METROPOLITAN GOVERNMENT OF NASHVILLE AND DAVIDSON COUNTY

STAFF RECOMMENDATION 1611 Gartland Avenue March 15, 2016

Application: Partial demolition; New construction--infill
District: Lockeland Springs-East End Neighborhood Conservation Zoning Overlay
Council District: 06
Map and Parcel Number: 08310014200
Applicant: Cheyenne Smith
Project Lead: Melissa Baldock, melissa.baldock@nashville.gov

Figure 1. 1611 Gartland Avenue

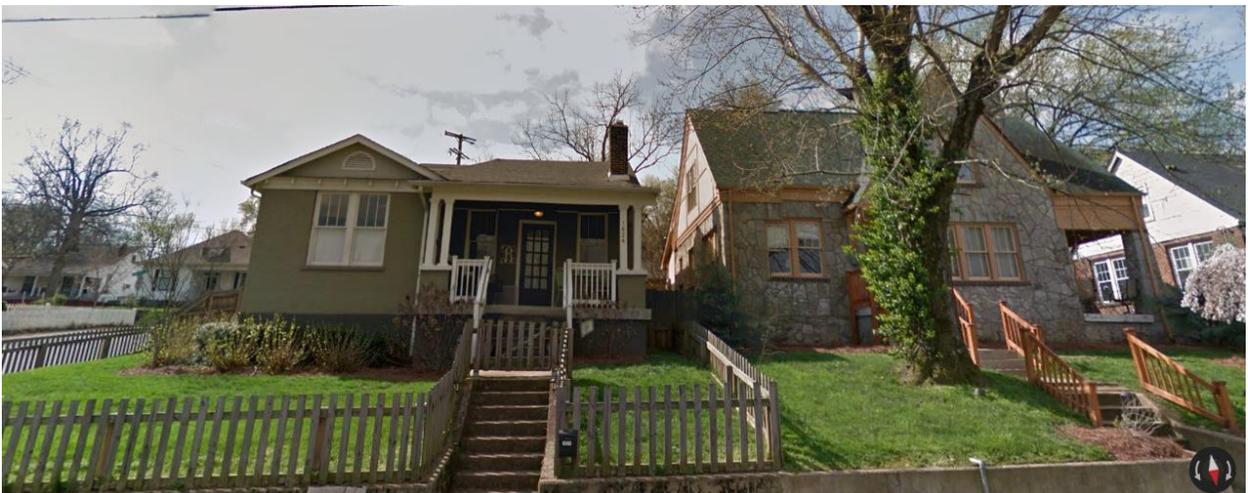
Background: 1611 Gartland Avenue was constructed between 1947 and 1951, outside of the period of significance of the Lockeland Springs-East End Neighborhood Conservation Zoning Overlay (Figure 1).

01 SITE PLAN

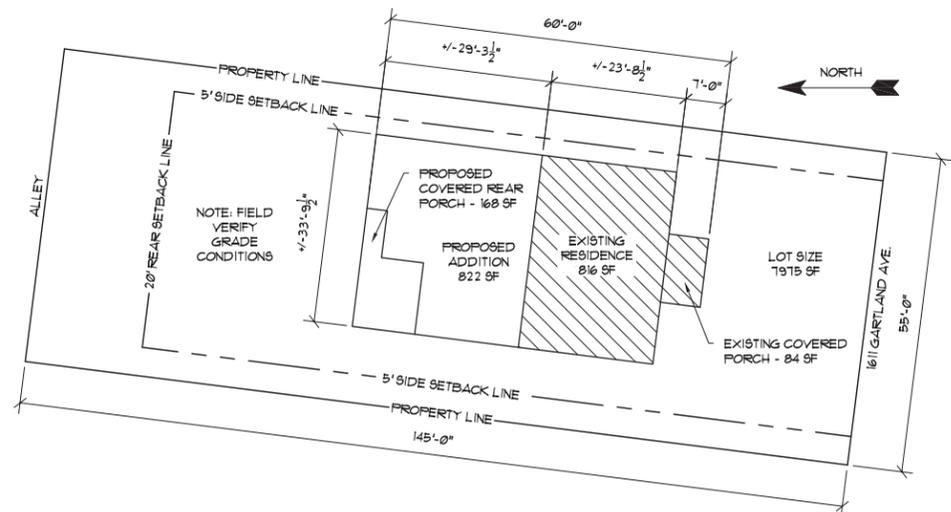
Setback & Rhythm of Spacing: The proposed house will meet all base zoning setbacks. Its front and side setbacks will remain the same as what is existing. It will be approximately thirty-six feet (36') from the front property line, fourteen feet (14') from the left side property line, and eight feet (8') from the right side property line. Staff finds that the project's setback and rhythm of spacing meet Section II.B.3. of the design guidelines.

Appurtenances & Utilities: No changes to the site’s appurtenances were indicated on the drawings. The location of the HVAC and other utilities was not noted. Staff asks that the HVAC be located on the rear façade, or on a side façade beyond the midpoint of the house.

3. The HVAC shall be located behind the house or on either side, beyond the mid-point of the house; and
4. A walkway be added from the street to the front porch.

02 DEMOLITION PLAN

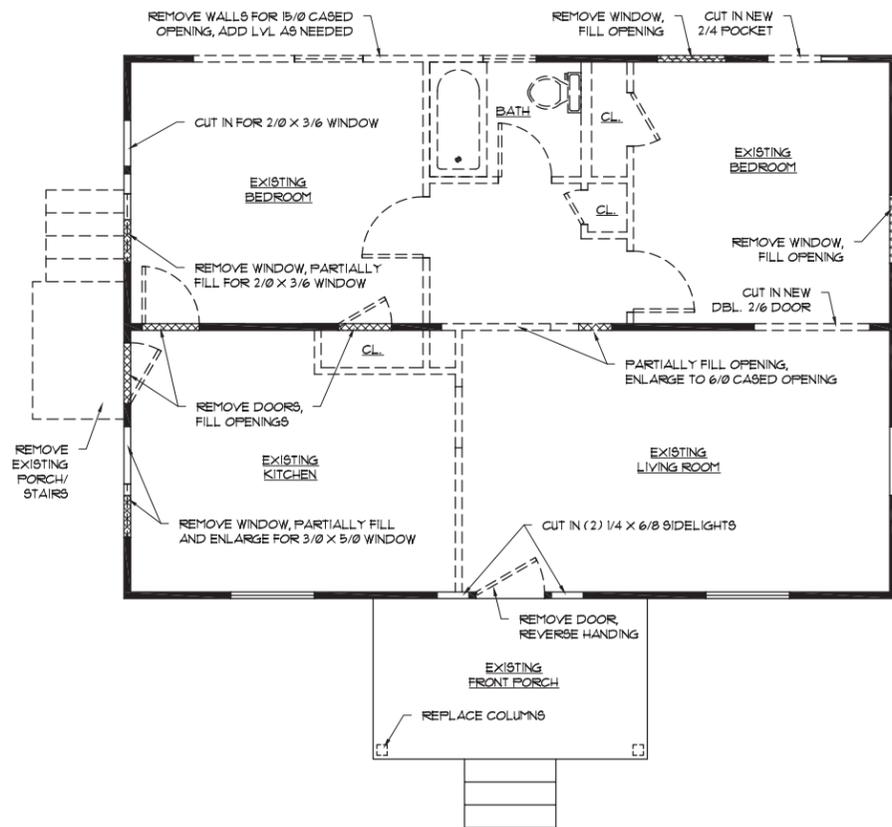
Demolition: The applicant intends to demolish the existing roof and porch and to substantially alter the existing house. Because the existing house's roof form, materials, and design do not contribute to the historic character of the Lockeland Springs-East End Neighborhood Conservation Zoning Overlay, staff finds that the proposed demolition

EXTERIOR ELEVATIONS

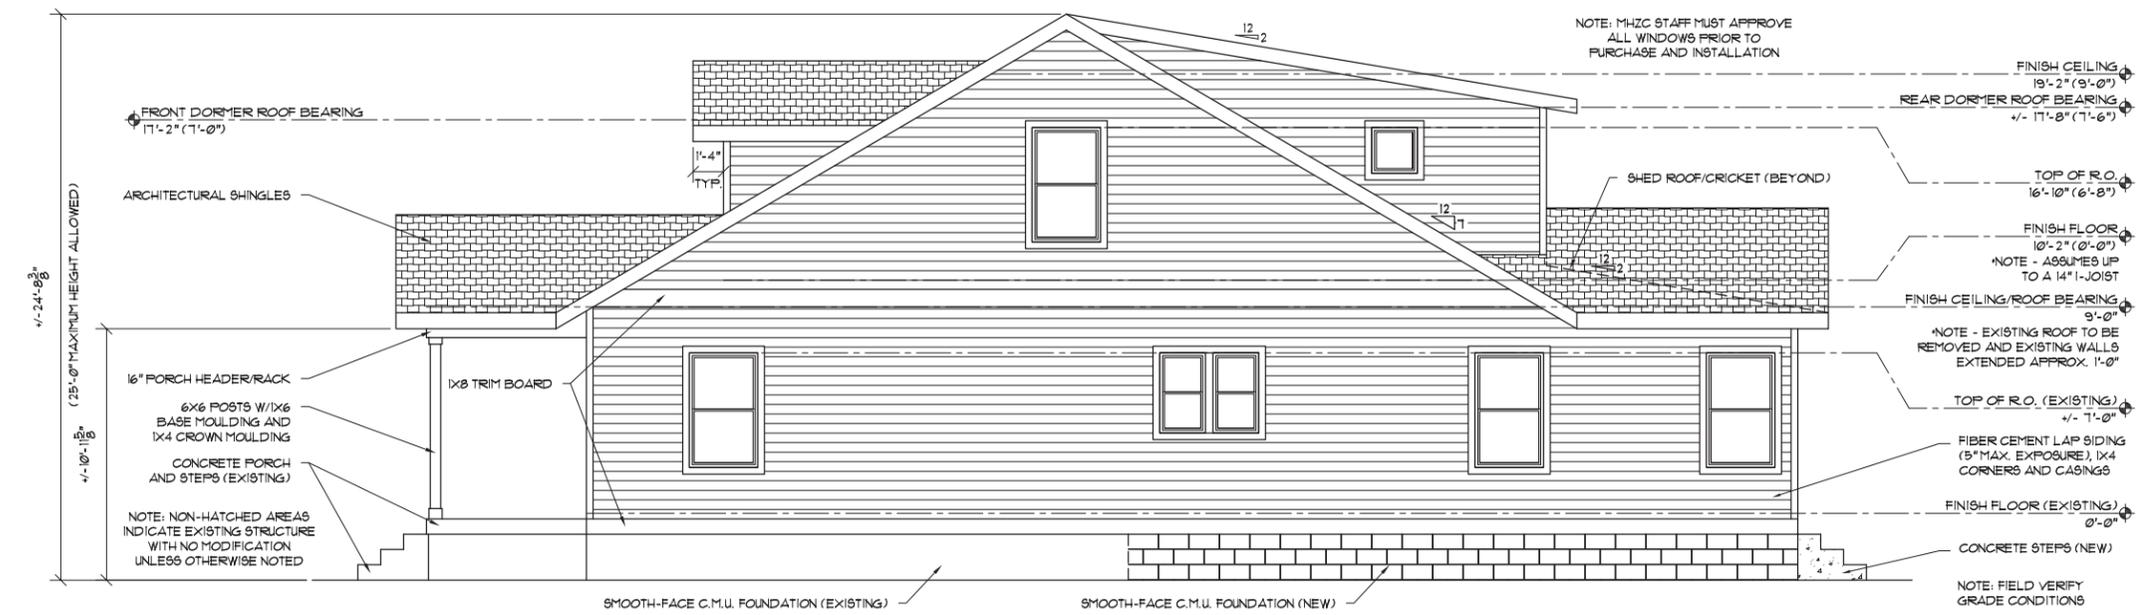
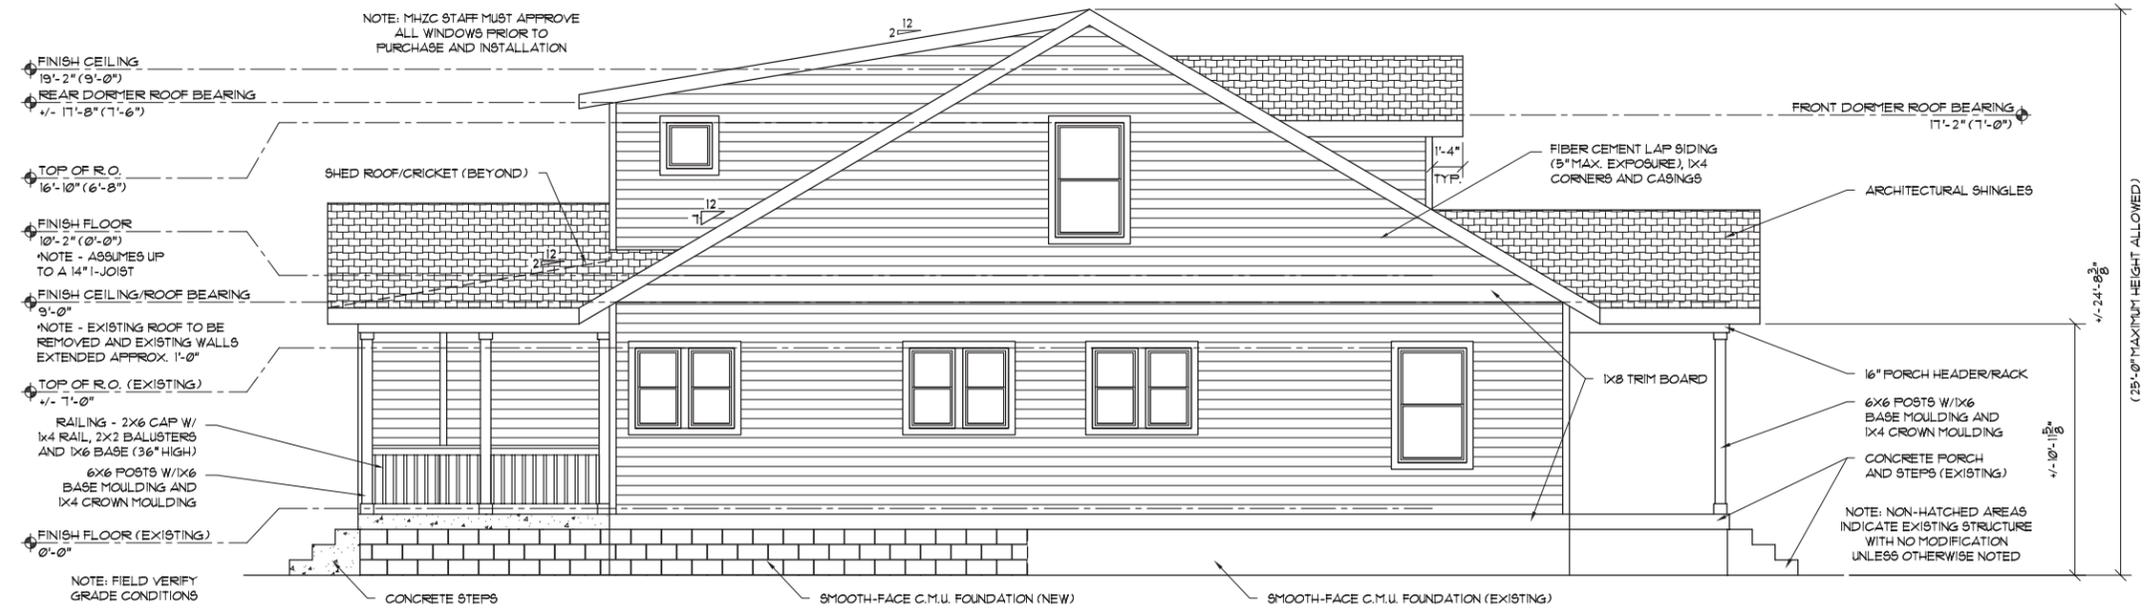
Height & Scale: The new house design will have an eave height of approximately eleven feet (11') and a ridge height of twenty-four feet, eight inches (24'8"). This is in keeping with the historic context, where historic houses range in height from nineteen feet to twenty-four feet (19'-24'). The width of the house will remain the same as the existing house and will be thirty-three feet, nine inches (33'9"). This is in keeping with the historic context where historic houses range from twenty-seven to forty feet (27'-40') wide. The depth of the house will increase from approximately twenty-three feet (23') to approximately sixty feet (60'), which staff finds to be appropriate. Staff finds that the house's height and scale meet Sections II.B.1. and II.B.2. of the design guidelines.

Roof form: The new primary roof form will be a side gable with a 7/12 slope. The front slope will have two small gabled dormers that are inset five feet (5’) from the wall below. On the rear slope will be a 2/12 shed dormer and two gabled one-story bays. Staff finds the proposed roof forms are compatible with those of the historic neighborhood and meet Section II.B.5. of the design guidelines.

Proportion and Rhythm of Openings: The windows on the proposed house are generally twice as tall as they are wide, thereby meeting the historic proportions of openings. There are no large expanses of wall space without a window or door opening. Staff finds the project’s proportion and rhythm of openings to meet Section II.B.7. of the design guidelines.
